Job:
Proposed extension at:
3, Wiltshire Drive,
Wokingham,
Berkshire.
RG40 1TQ

Amended Plans

Drwg: Prop. East/West Elevations

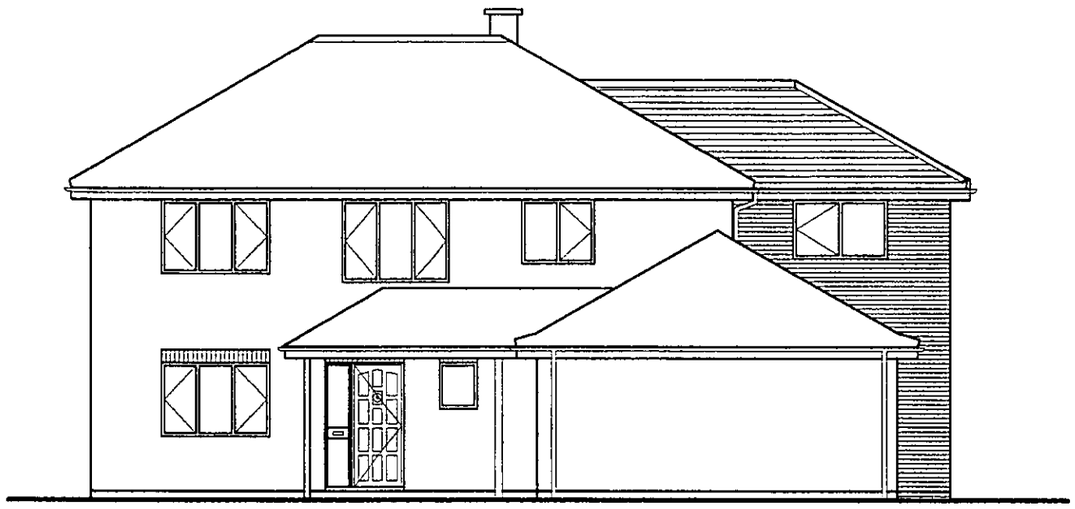
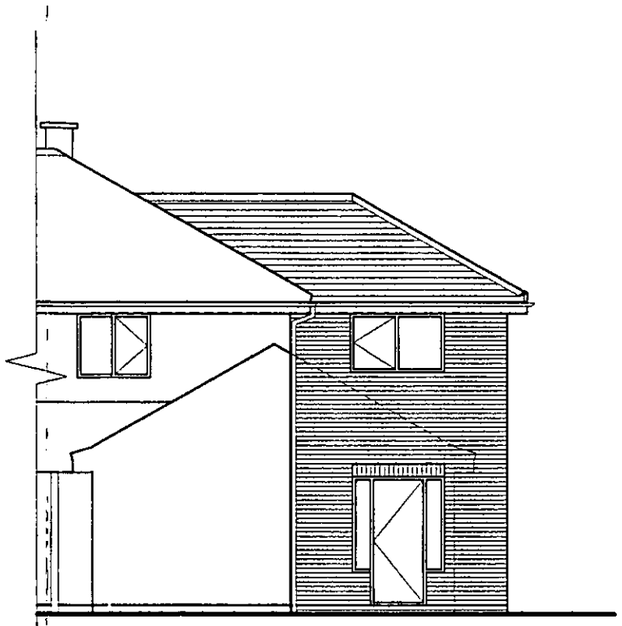
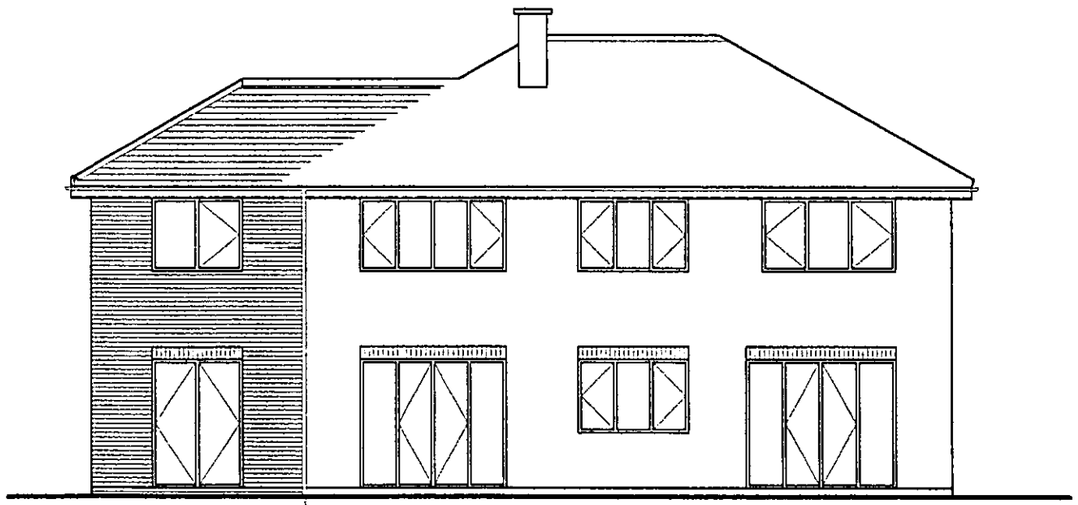
Extg. RWP relocated to conceal joint in brickwork.

AMENDMENT SCHEDULE		
Date	No.	Description
03.03.03	1	Lounge patio door to rear changed to french casement.
		Proposed bedroom 5 front window changed to
		1050 x 1370mm.
21.05.03	2	Proposed bedroom 5 front window changed to
		950 x 1514mm.

Drwg: Prop. East/West Elevations

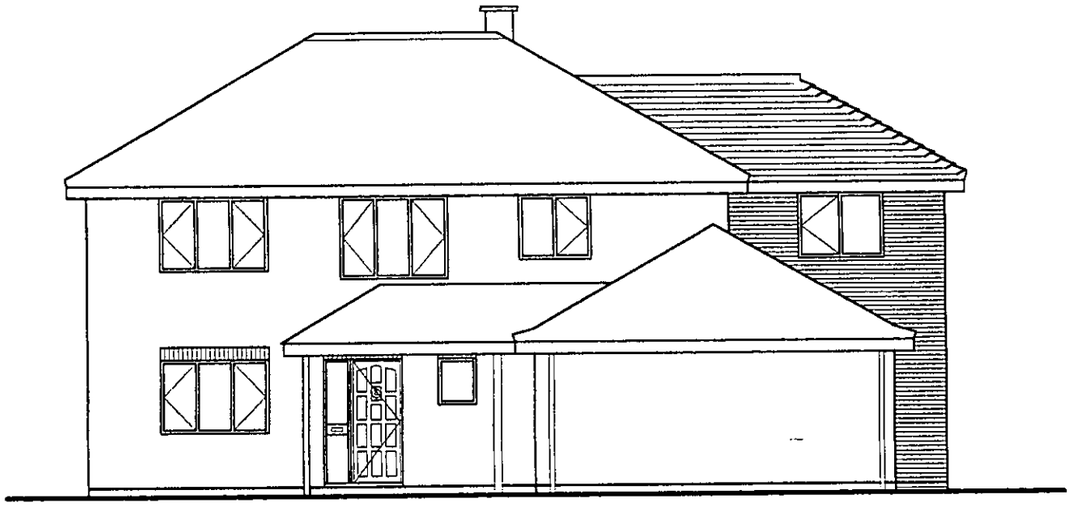
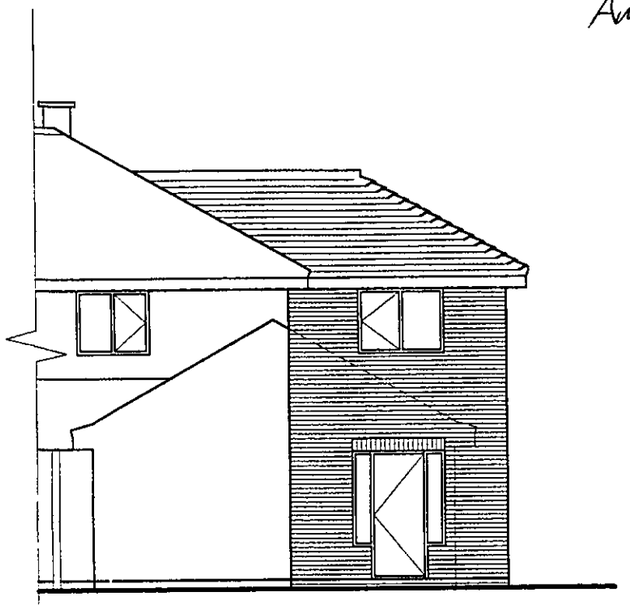
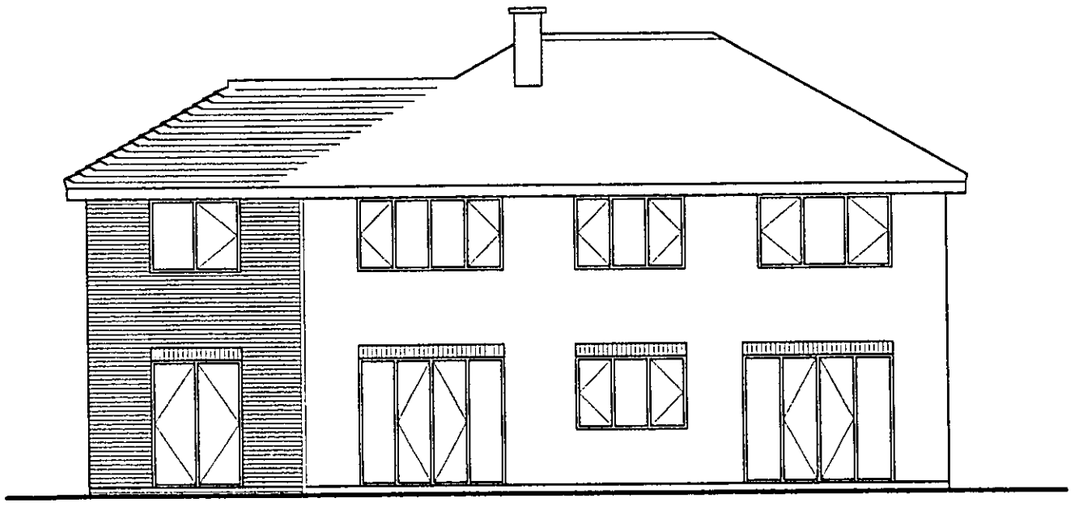
AMENDMENT SCHEDULE		
Date	No.	Description
03.03.03	1	Lounge patio door to rear changed to french casement. Proposed bedroom 5 front window changed to 1050 x 1370mm.

Drwg: Prop. East/West Elevations

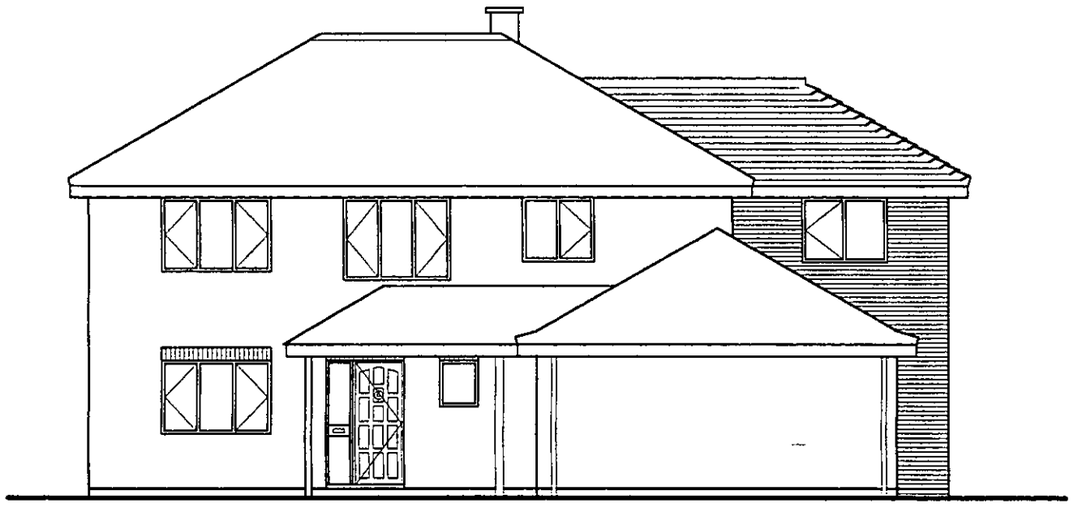
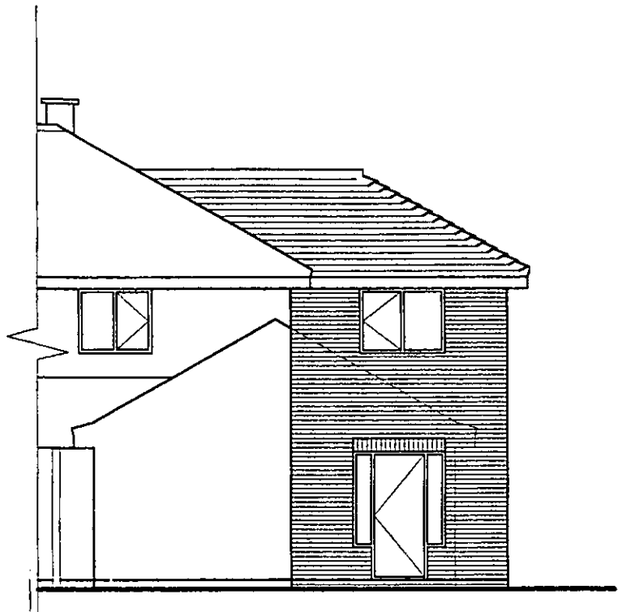
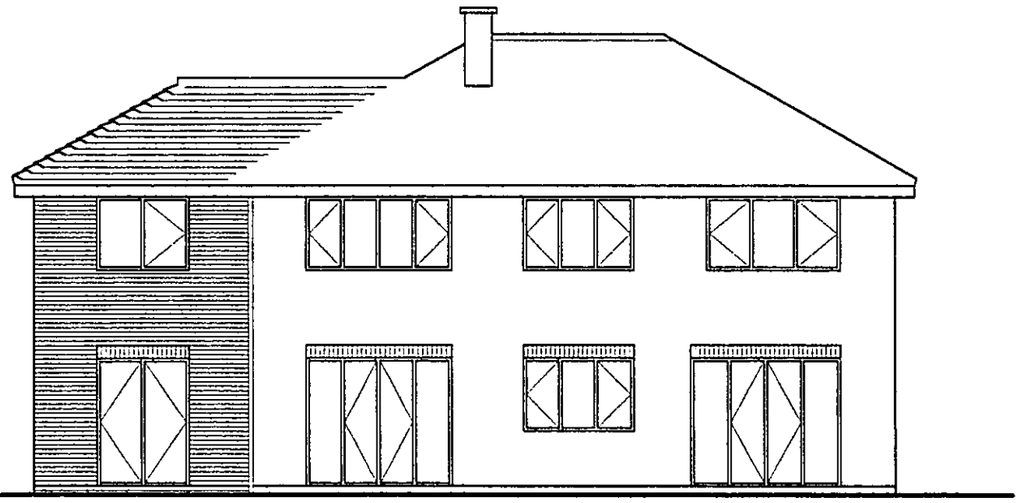
AMENDMENT SCHEDULE		
Date	No.	Description
03.03.03	1	Lounge patio door to rear changed to french casement. Proposed bedroom 5 front window changed to 1050 x 1370mm.

Drwg:
Proposed Ground Floor Plan

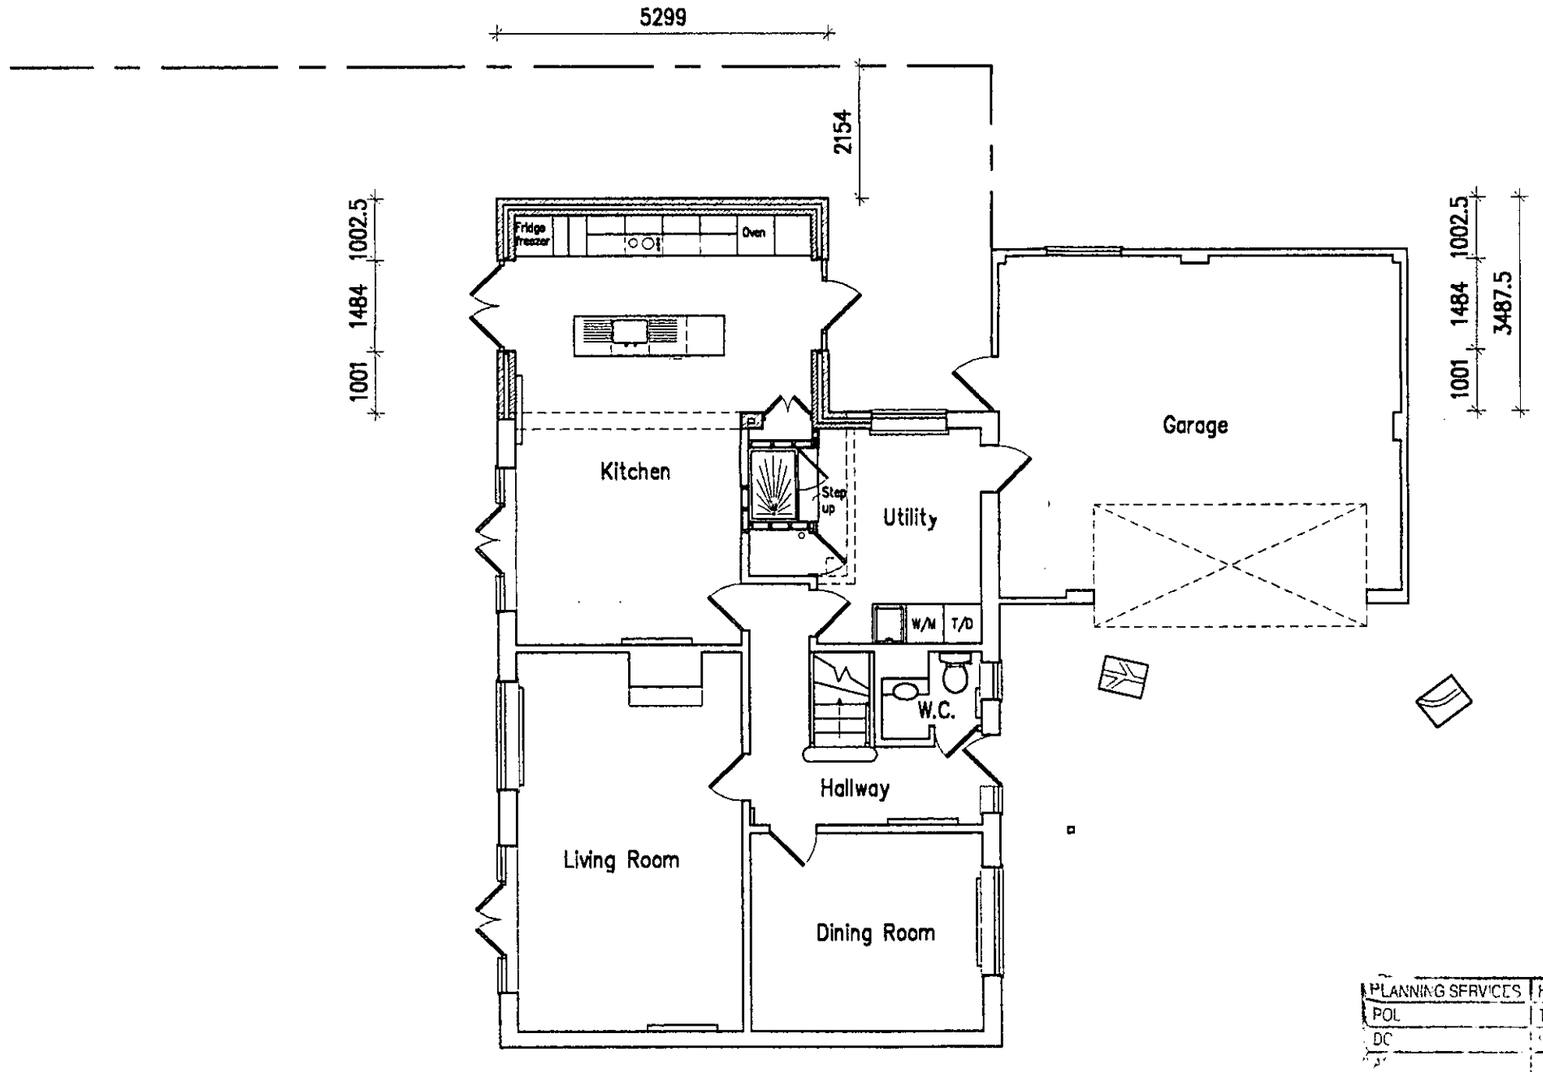
AMENDMENT SCHEDULE		
Date	No.	Description
21.11.02	1	Western window to kitchen area replaced with french doors
03.03.03	2	Living room door rehung. Garage to utility rm door repositioned. Kitchen and utility rm layouts amended

Drwg:
Proposed Ground Floor Plan

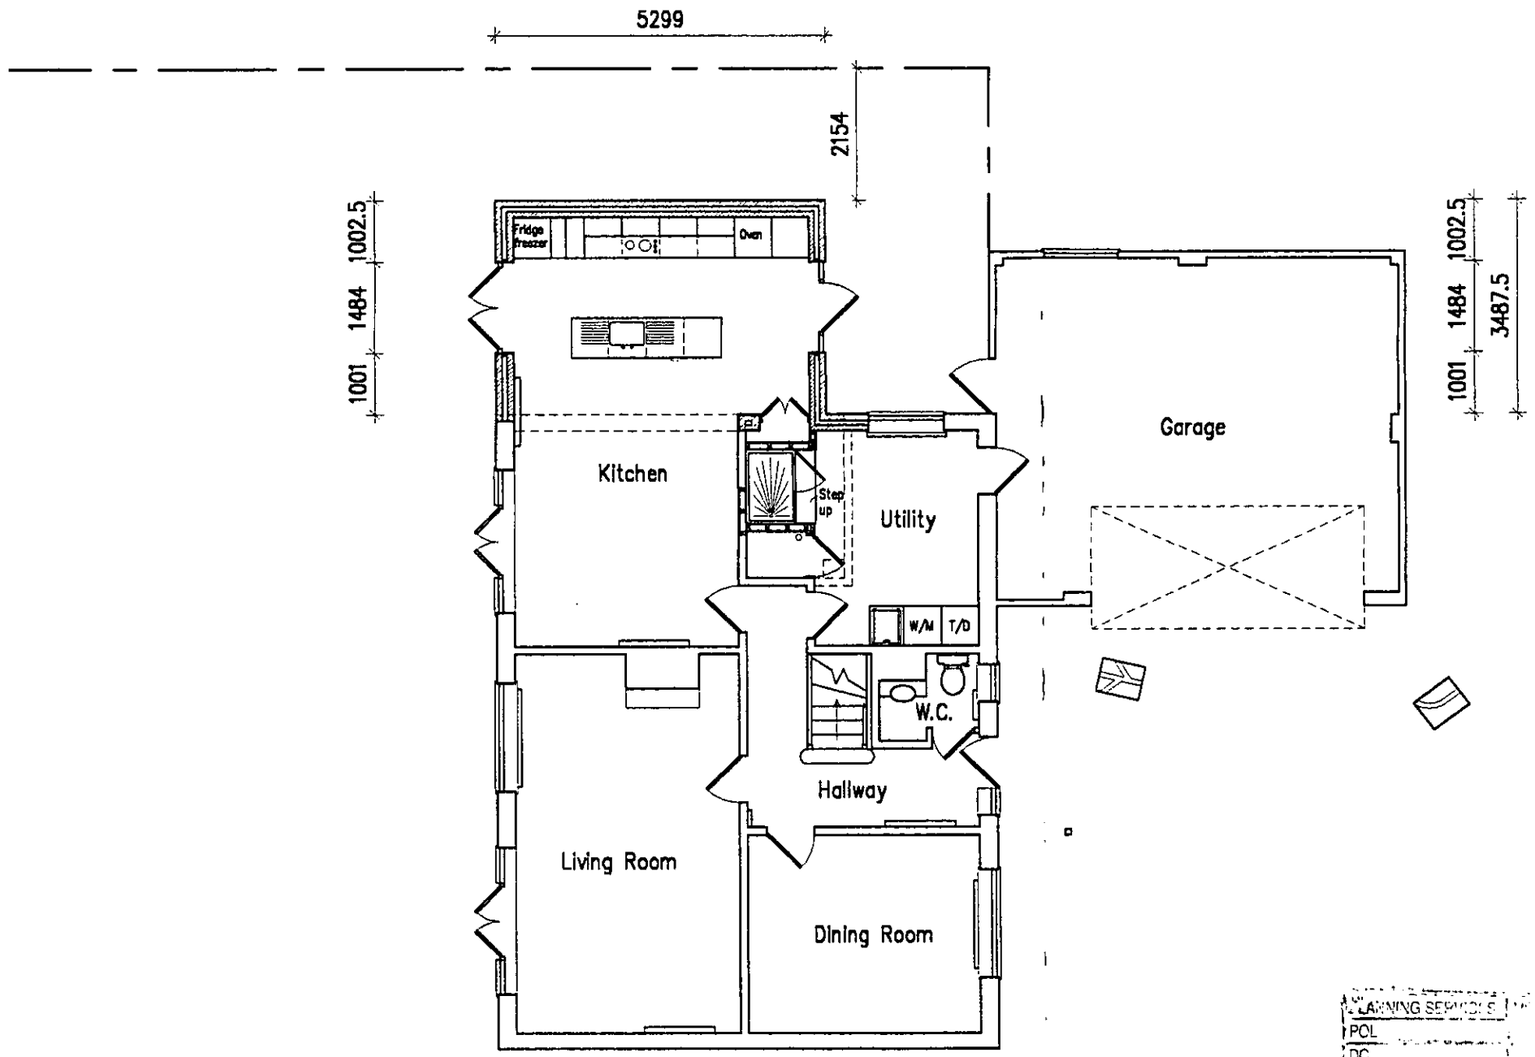
AMENDMENT SCHEDULE		
Date	No.	Description
21.11.02	1	Western window to kitchen area replaced with french doors
03.03.03	2	Living room door rehung. Garage to utility rm door repositioned. Kitchen and utility rm layouts amended

Drwg: Proposed First Floor Plan

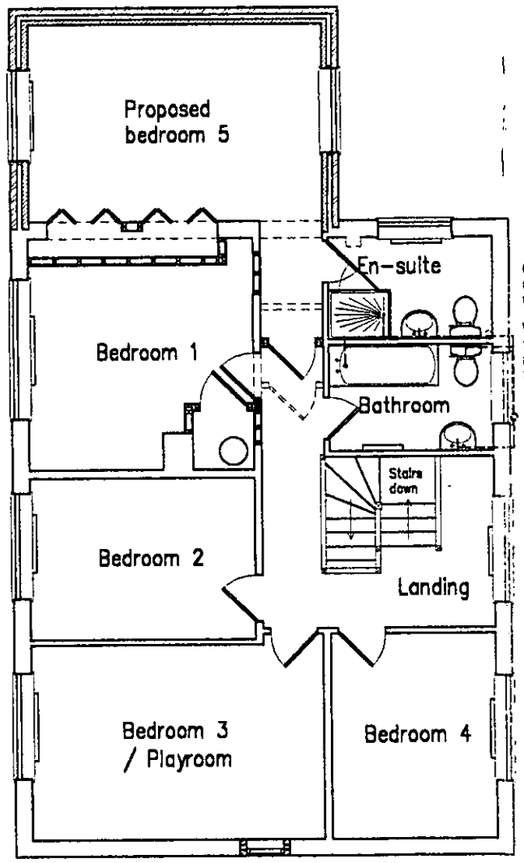
AMENDMENT SCHEDULE		
Date	No.	Description
03.03.03	1	Front window to Bed 5 widened to 1370mm. Partitioning within Bed 1 altered. Bathroom layouts altered.

Drwg: Proposed First Floor Plan

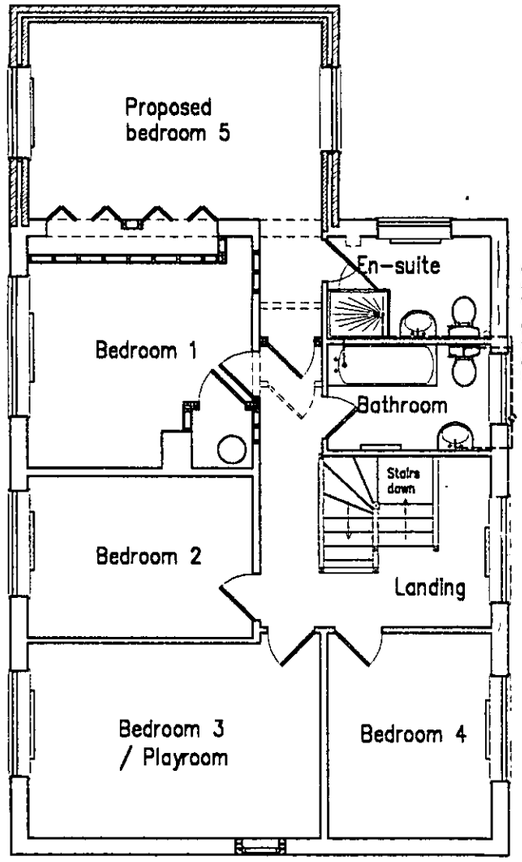
AMENDMENT SCHEDULE		
Date	No.	Description
03.03.03	1	Front window to Bed 5 widened to 1370mm. Partitioning within Bed 1 altered. Bathroom layouts altered.
